May 5, 2023

**Re: 7-Brews**  
**4331 Wyoming Blvd. NE**  
**Traffic Circulation Layout**  
Architect's Stamp 04-19-23 (G19-D004F)

Based upon the information provided in your submittal received 04-24-23, the above referenced plan cannot be approved for Building Permit until the following comments are addressed:

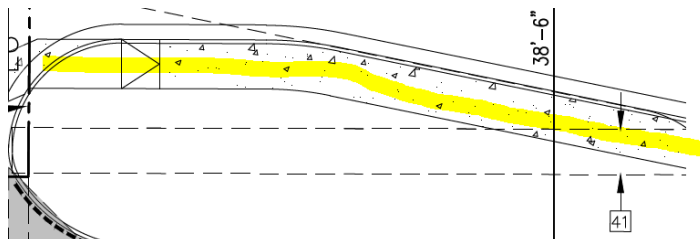
6. Is this a proposed sidewalk? Please provide details and reference COA std dwg.
